## SERVICE BULLETIN MAINTENANCE OF WAY EQUIPMENT

**DATE:** 12-12-2002 **BULLETIN NO:** 02-032

**TITLE:** MODULE PANEL POWER SUPPLY

**PRODUCT SERIES / MODEL:** 6700 and 6700S Tampers

FIGURE 1  
OLD POWER SUPPLY ASSEMBLY

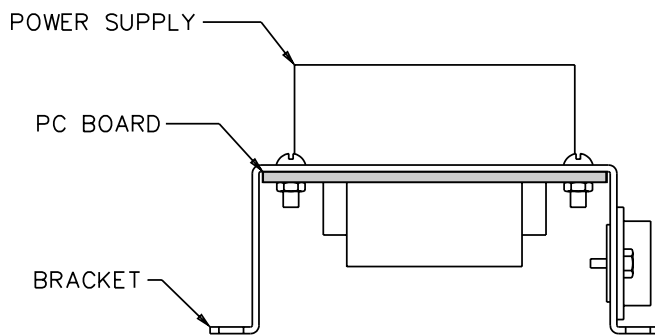
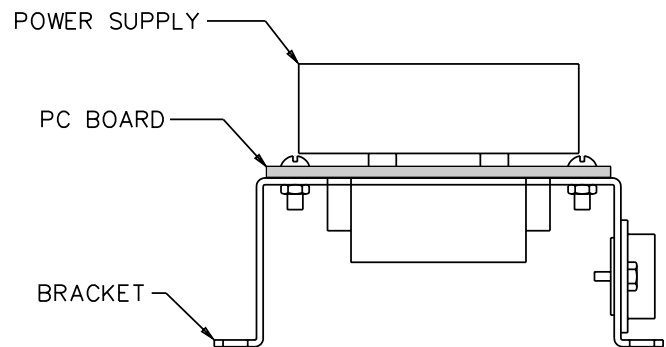
1. See Figure 1. On the old power supplies (#231646-1 and #231991-1), the printed circuit board mounts inside of the bracket.
2. See Figure 2. On the new power supplies (#2005988 and #2005987), the printed circuit board is mounted on the top of the bracket. This allows the bracket to flex without stressing the printed circuit board. The sockets on the printed circuit board into which the power supply is mounted have also been changed to an open end style instead of a closed end style to prevent vibration between the bottom of the socket and the end of the power supply pin, which could travel up the pin and stress the connection inside of the power supply.

3. Replace old power supplies with new power supplies as required:  
 Old Power Supply #231646-1 is replaced by New Power Supply #2005988  
 Old Power Supply #231991-1 is replaced by New Power Supply #2005987
4. Any failed power supply sent in for repair or replacement will be modified to the new configuration. This involves replacing the sockets on the printed circuit board and remounting the printed circuit board on the top of the bracket.
5. **Note:** It is important that the whole power supply assembly be sent in, not just the power supply (brick) itself. The pin length of the power supply on the new assemblies is longer and will bottom out on the old sockets. The power supply assembly will be returned with a new set of prints for the Parts Manual.
